Access Compliance Report Public Rights-of-Way (Curb Ramps)

Main Street: CLYDESDALE_DR		Cross Street: CLYDESDALE_DR		Location:	S
ADA ID: RPRK211110132627	Ramp Type:Type 1 - Perpendicular	Initial Pass/Fail: Fail	Overall Compliance: No	Severity Score:	30

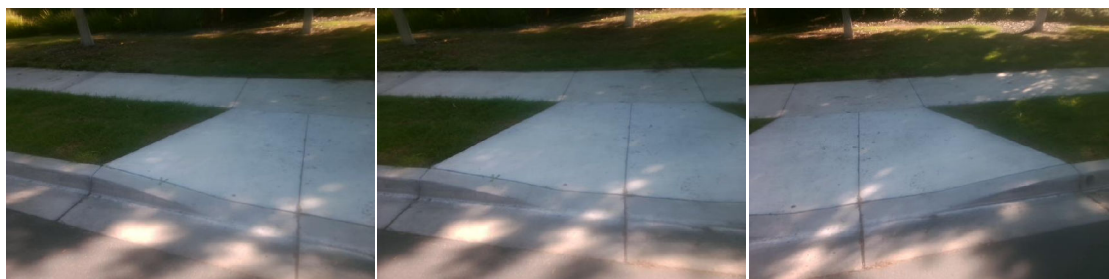
R304.2.2, R204.3, R304.5.3, STD 1115

Compliance	Description	Data	Compliance	Description	Data
N/A	Ramp Length (in)	56	N/A	Flare Type LT	
Yes	Ramp Width (in)	54			N/A
No	Ramp Run Slope (%)	9.9	N/A	Flare Slope LT (%)	N/A
No	Ramp Cross Slope (%)	5.4	N/A	Flare Traversable LT	N/A
N/A	Landing Present	N/A	N/A	Flare Type RT	
N/A	Landing Length (in)	N/A			N/A
N/A	Landing Width (in)	N/A	N/A	Flare Slope RT (%)	N/A
N/A	Landing Run Slope (%)	N/A	N/A	Flare Traversable RT	N/A
N/A	Landing Cross Slope (%)	N/A	N/A	DWS Provided	N/A
N/A	Landing Movement Obstructed?	N/A	N/A	DWS Contrast	N/A
	Landing Movement Type	N/A	N/A	DWS Length (in)	N/A
N/A	Landing Shared	N/A	N/A	DWS Full Width	N/A
N/A	Clear Space	N/A	N/A	DWS Offset Left (in)	N/A
N/A	Clear Space To Crosswalk (in)	N/A	N/A	DWS Offset Right (in)	N/A
N/A	Marked Crosswalk 1	No	N/A	Marked Crosswalk 2	N/A
	Crossing 1 Direction	NW		Crossing 2 Direction	N/A
	Marked Crosswalk 1 Width (in)	N/A		Marked Crosswalk 2 Width (in)	N/A

Remove & Replace Entire Ramp.
